Review of “A multi-purpose, multi-rotor drone system for long range and high-altitude volcanic gas plume measurements”

Submitted to Atmospheric Measurement Techniques (AMT)

Review by Peter Kelly, USGS, Jan 20, 2021

Figure showing CO₂ and SO₂ data from Liu et al., 2020 supplement ‘abb9103_Table_S2’, perhaps showing data from the multiGAS unit described in the present work(?). Note that the second SO₂ peak is truncated and that CO₂ and SO₂ are poorly correlated.

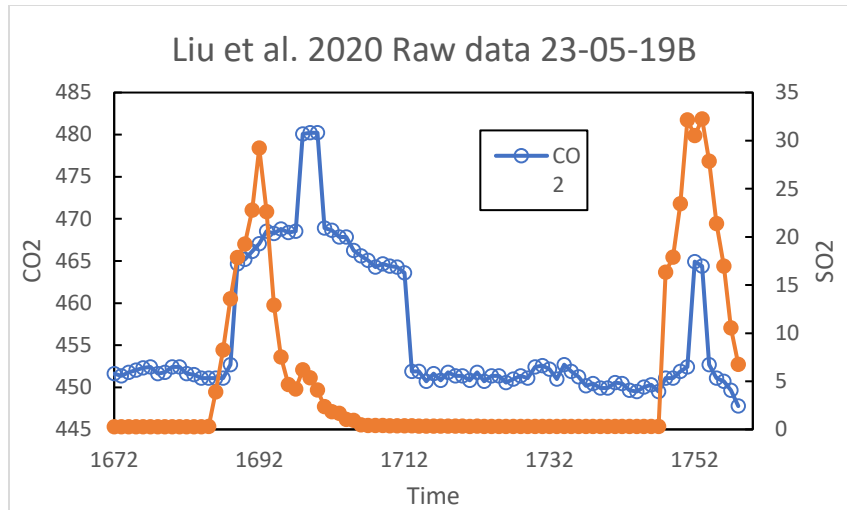
If my hunch is correct, then what I take to be Chalmers multiGAS data from May 23 appear to be very poor, and only show two SO₂ peaks near the end of the file (one of which is partially truncated; shown below) and CO₂ is poorly correlated with SO₂. The poor correlation between the CO₂ and SO₂ would appear to violate assumption 2 of the analysis routine (l. 383). Elsewhere the CO₂ data show large apparent jumps of ~15 ppm; is this some kind of interference? Finally I note that no units are given for any of the measurements, and the air temperature (T_{air}) appears to be listed in A/D counts(?) rather than sensible units (the 'T_{air}' values range from 5369 to 6805). I could not find data from the Sunkist unit anywhere.

It’s possible that these are the wrong data but based on the available information it is very difficult to be sure. This example makes it clear that the data from this experiment should be:

- better organized
- documented
- quality-assured
- checked for completeness
- made available in an open repository

At present, it is not possible to easily or unambiguously find or identify data from the described systems, which makes independent evaluation of their performances impossible. When preparing these data for release, please make sure that all necessary parameters (e.g. altitude) are included.

Figure S3 from Liu et al. (2020) supplement. Liu et al's Figure S3b is copied and presented as Figure 1 in the present work without correct attribution.

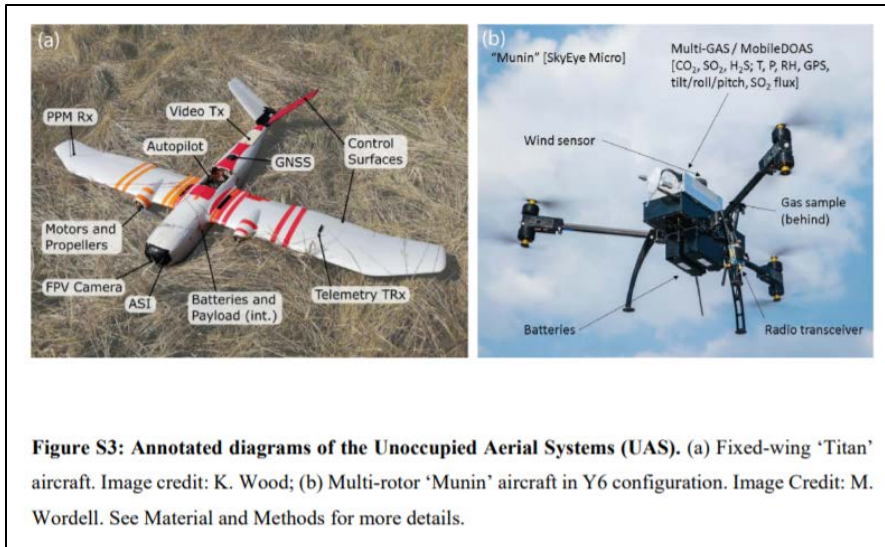
- Figure 1 of the manuscript is copied verbatim from Liu et al. (2020) supplement Figure S3b (shown below) and without correct attribution. Although the team for the two papers are much the same, ‘recycling’ figures in this way is poor practice and - at minimum - any previously published images and/or figures need to be cited properly.
